ADDENDUM NO. 1

ISSUE DATE: April 4, 2018

CRC College Center Expansion

LRCCD BID NO. 17021

SHEET NO:
AD2.10

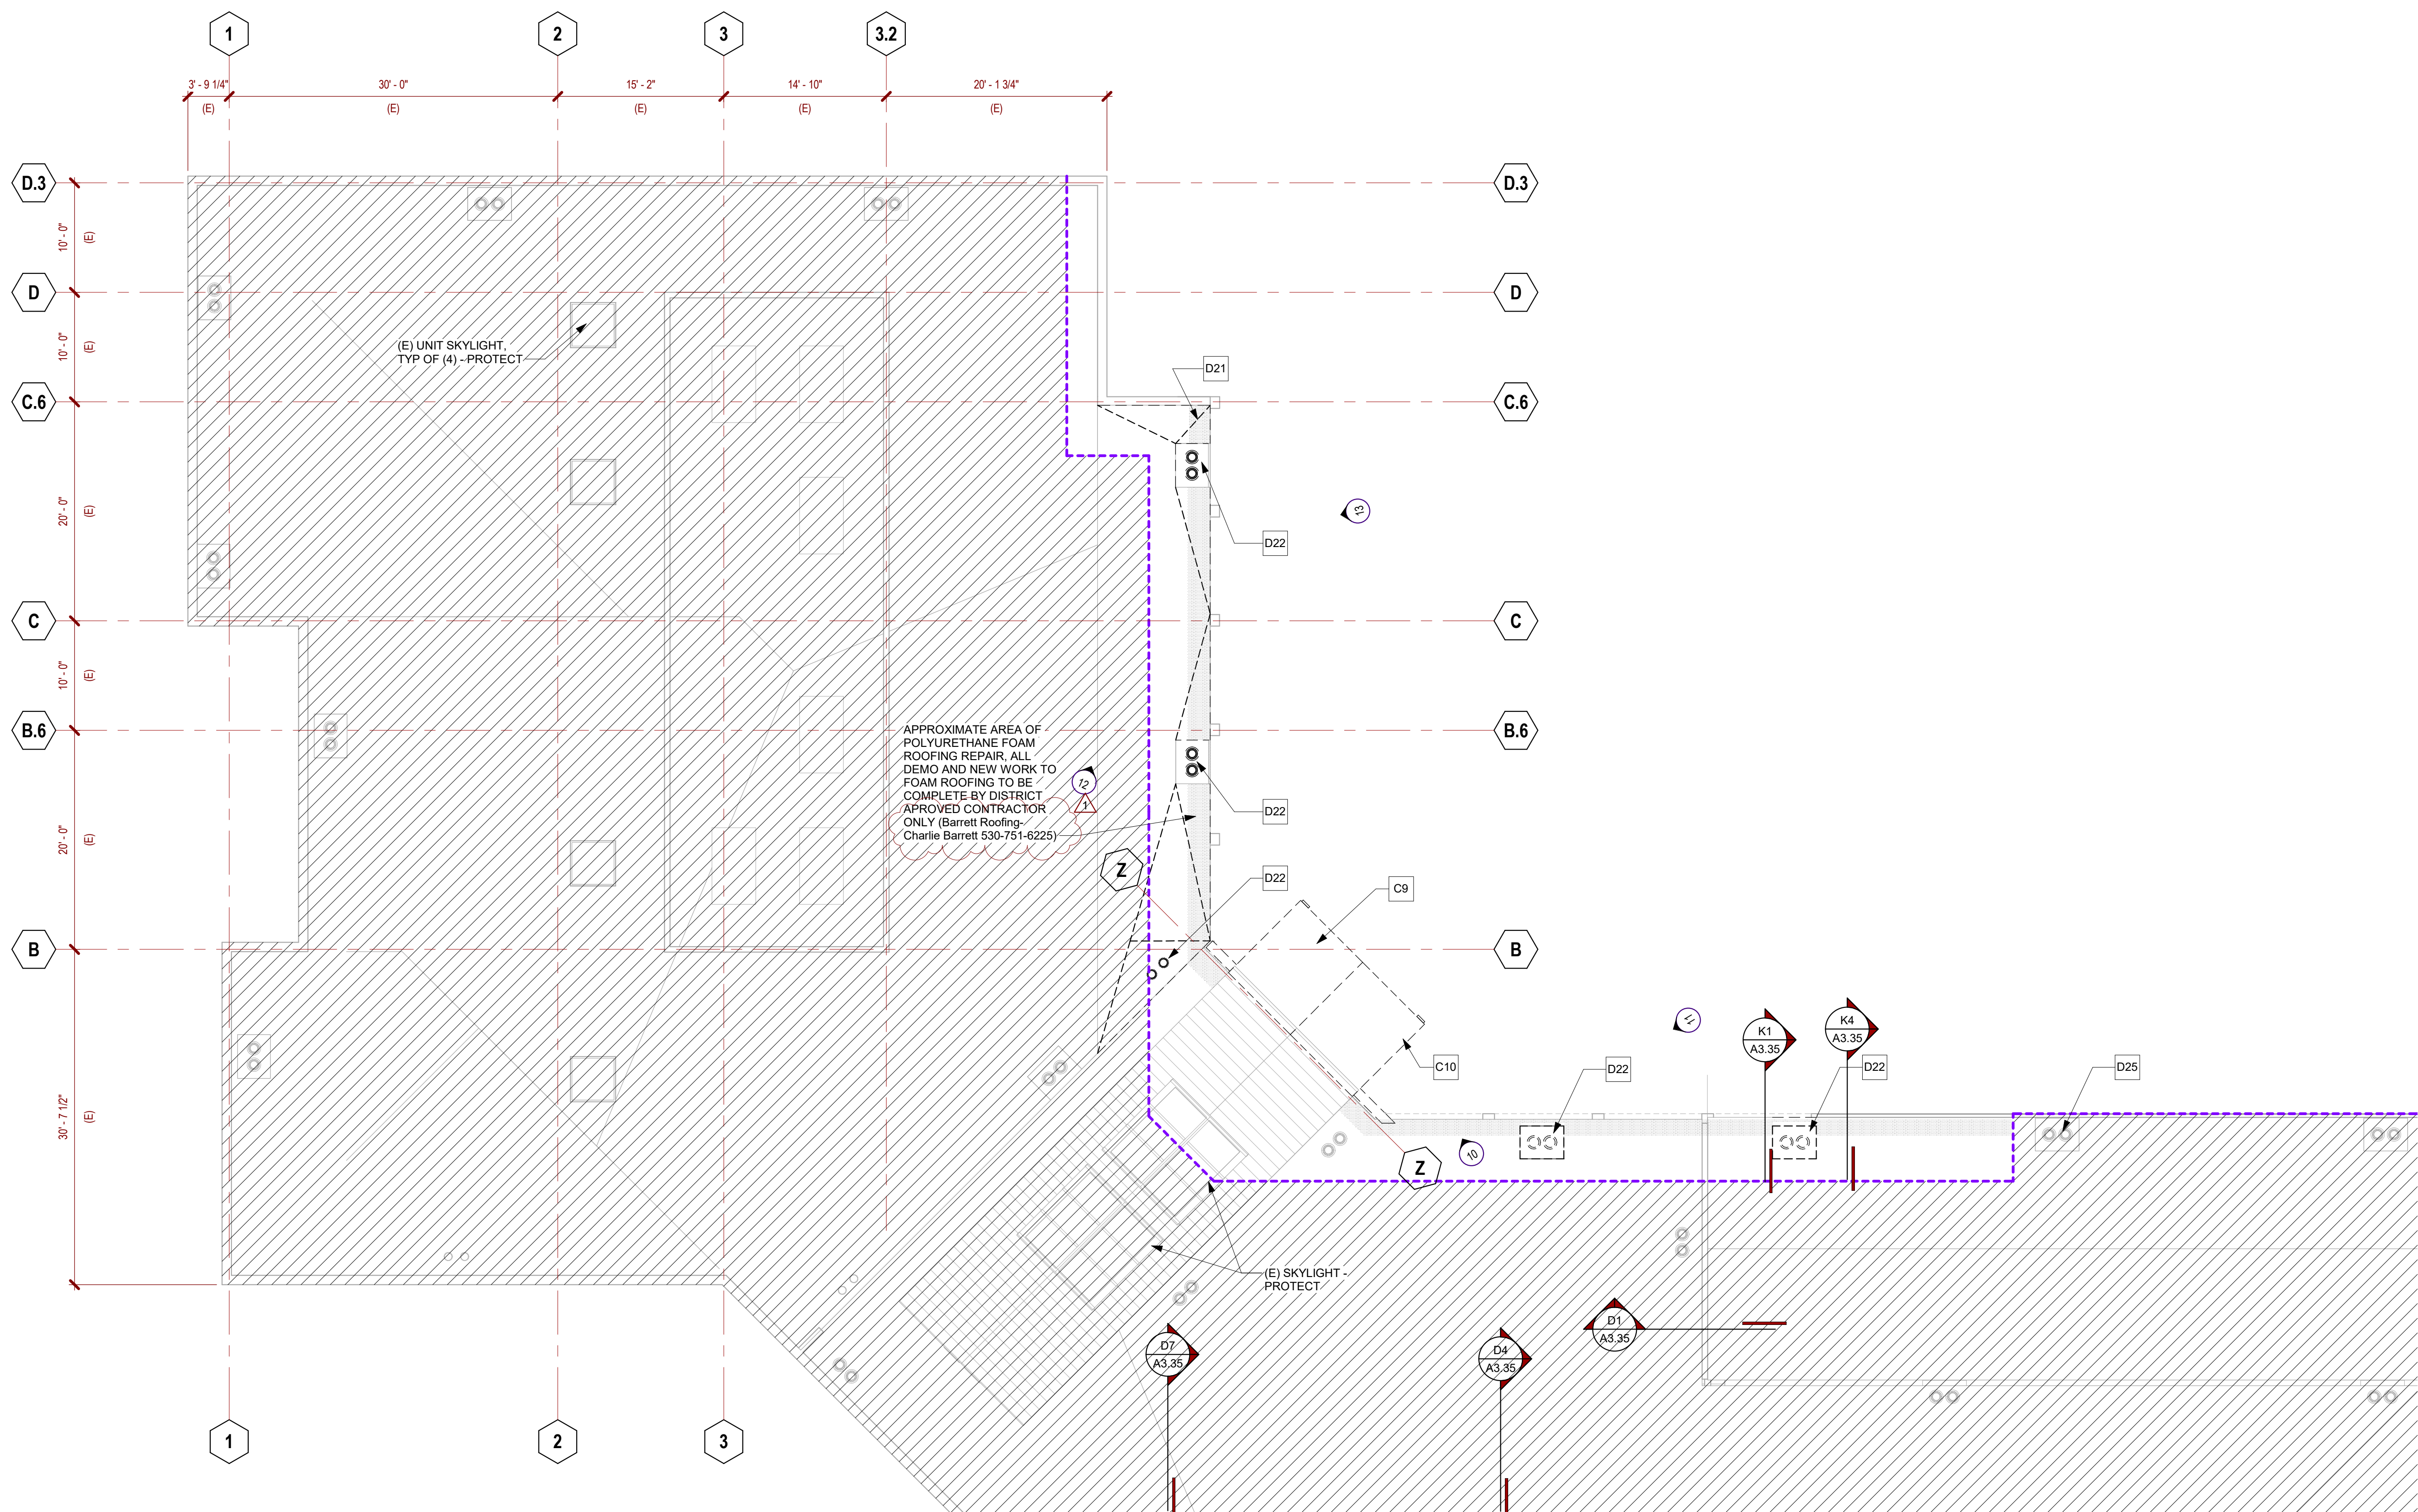
G0.10 – Modified Bid alternates
G0.11 – Modified sheet index
A0.31 – Modified keynotes
LD1.00 – Modified limit of work notes
AD2.00A – Modified scope of work boundary lines
AD2.00B – Modified scope of work boundary lines
AD2.10 – Modified contractor contact information
AD6.00A – Modified scope of work boundary lines
AD6.00B – Modified scope of work boundary lines
PD2.01 – The demolition of the sink scope was added
ED1.01 – Modified key notes and added coordination note for campus wide shut down
ED2.00A – Added demolition general notes and revised hatching.
ED2.00B – Added demolition general notes and revised hatching.
ED3.00 – Modified key note 1 security head end equipment for coordination with new location
FAD1.01 – Modified remodel area
A1.00 – Modified site plan
A2.01A – Modified scope of work boundary lines, wall types for “building support” 185, depressed slab, locations for j-box for future door actuator, and windows at transaction counter

PARTIAL FIRST FLOOR PLAN

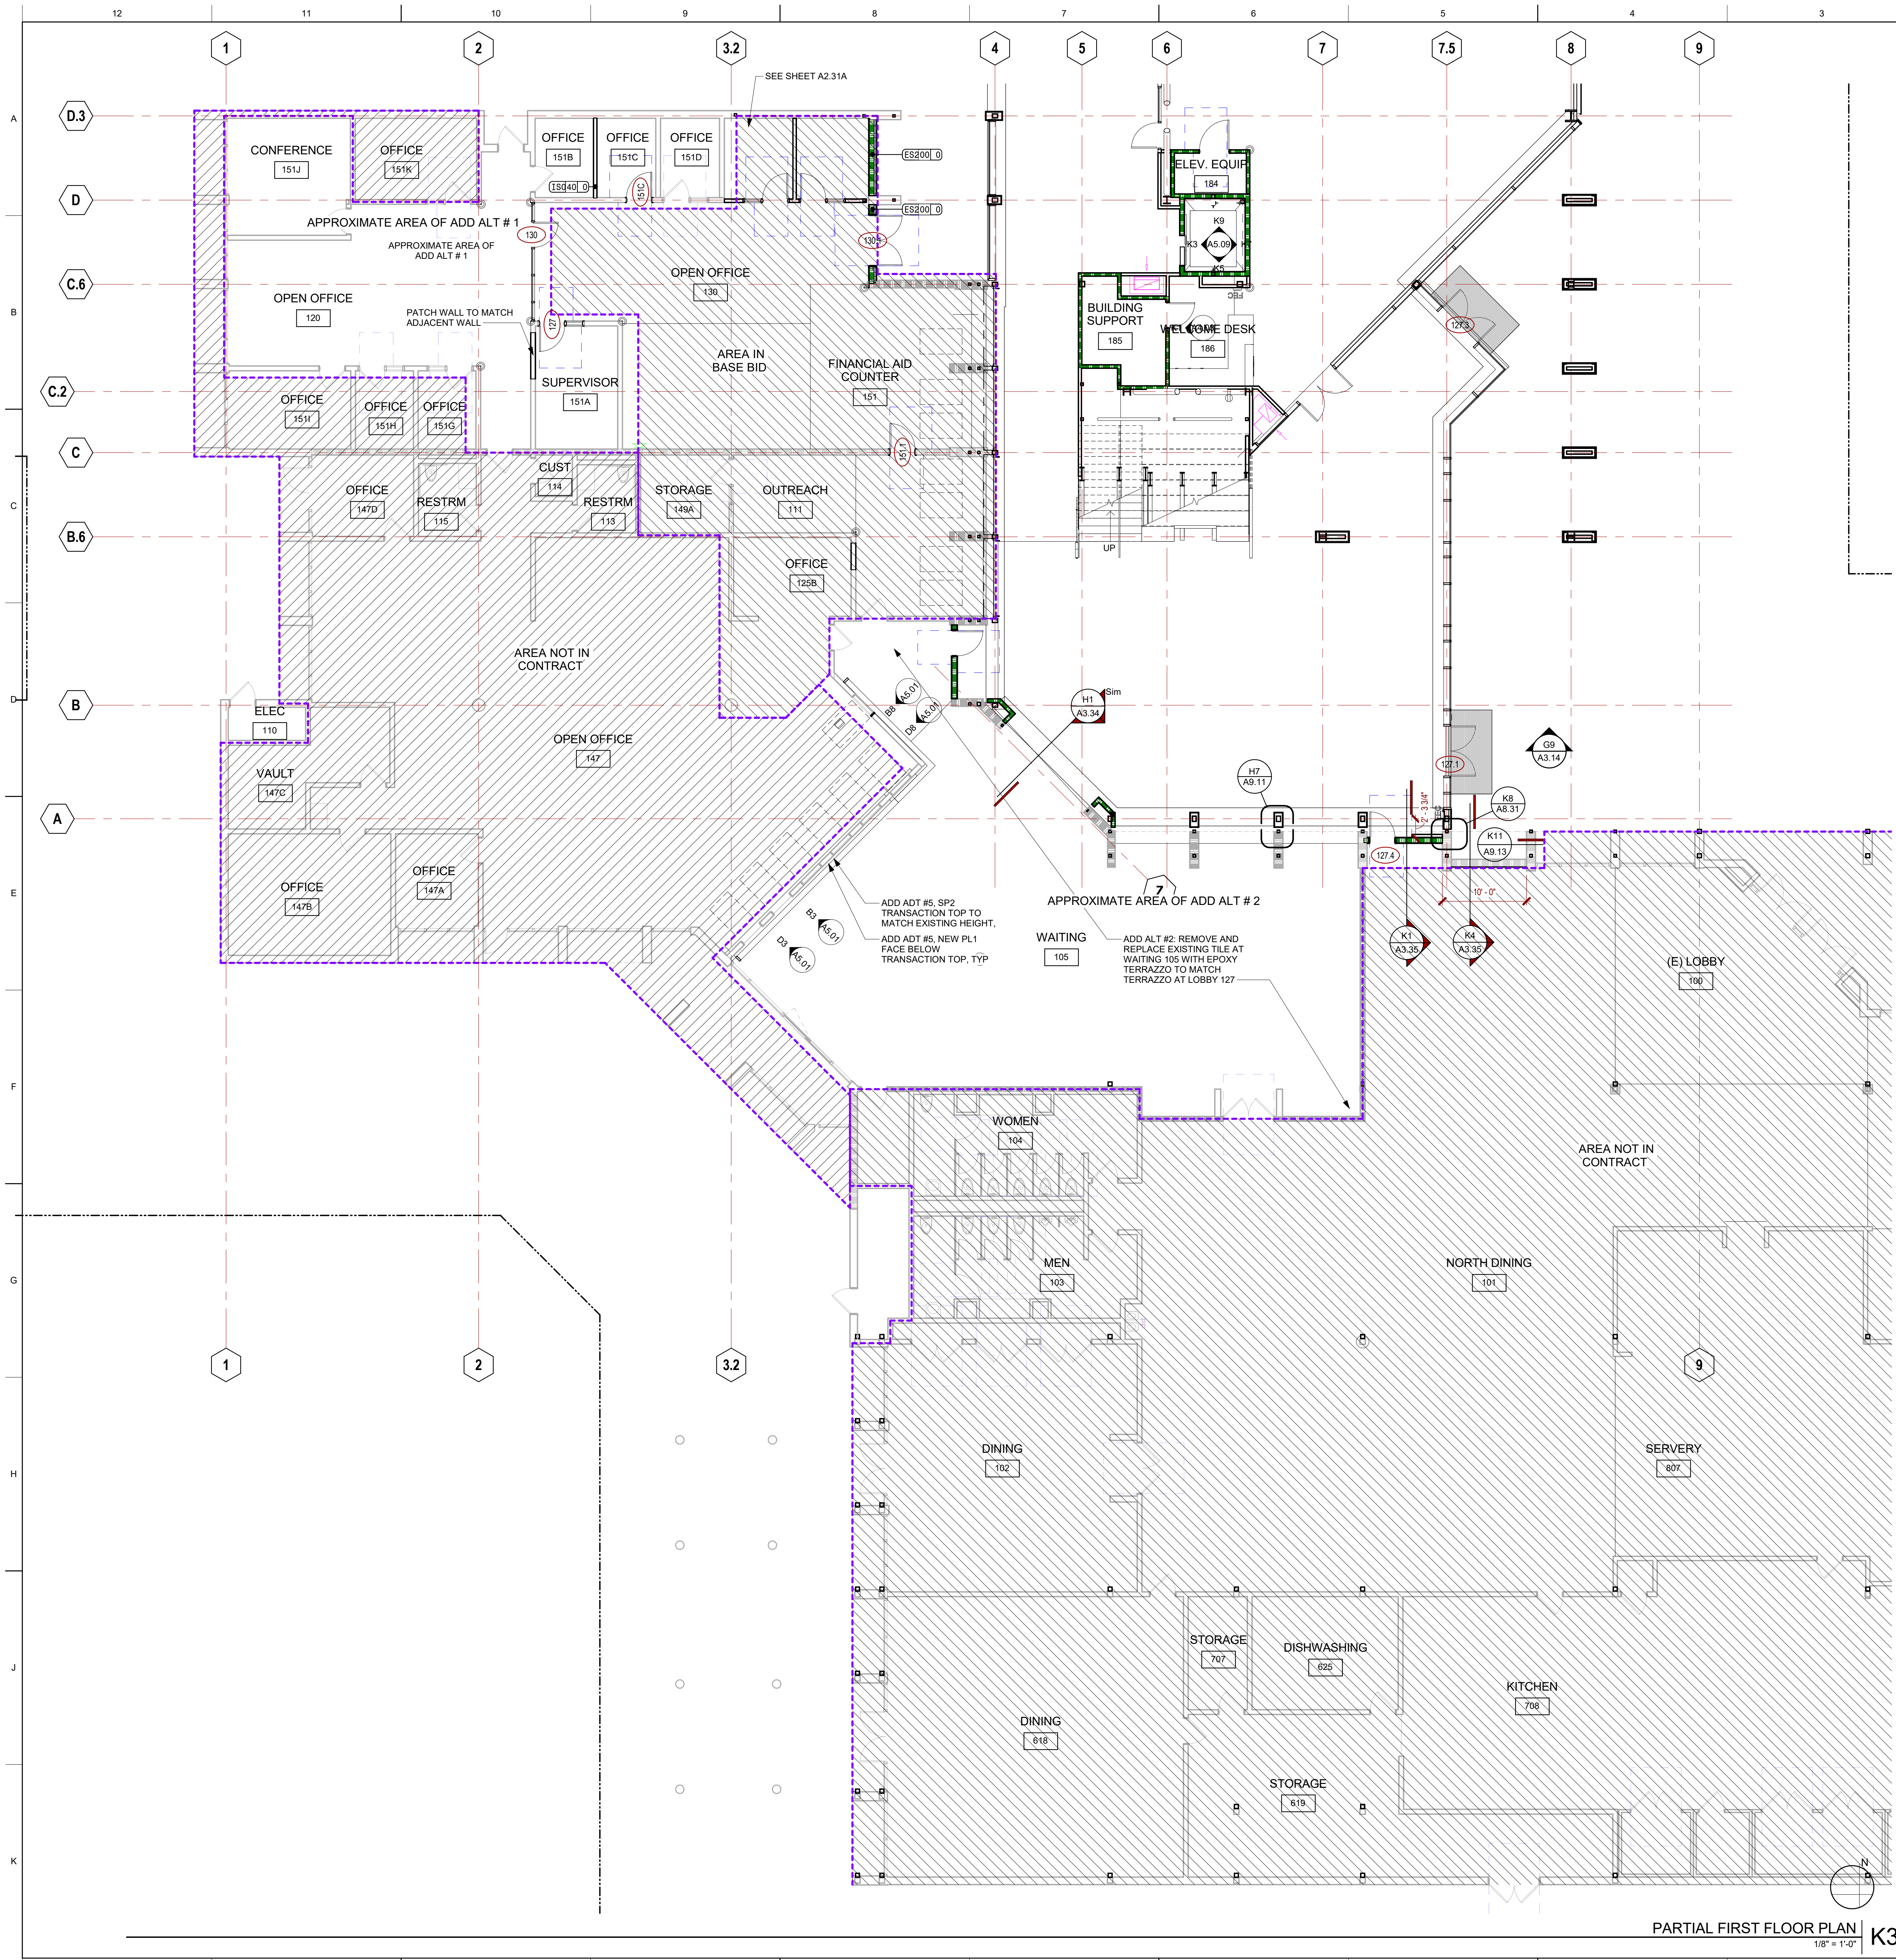
A2.01B – Modified scope of work boundary lines, general notes, floor plan symbols legend
A2.02 - Modified railing at stairs, walls at Open Office 254
A2.15 – Modified contractor contact information, detail tags
A2.30 – Modified finish material legend, wall combinations notes, general notes
A2.31A – Modified finish plan symbols, reception deck at reception 161Q, and updated finish tags
A2.31B – Removed graphics, finish plan symbols
A2.32 – Modified finish plan symbols, wall and deck at Open Office 254, and finish tags
A2.43 – Modified remarks column
A2.44 – Modified detail B9
A2.81 – Modified door schedule, door finish legend, door types, add fire curtain schedule
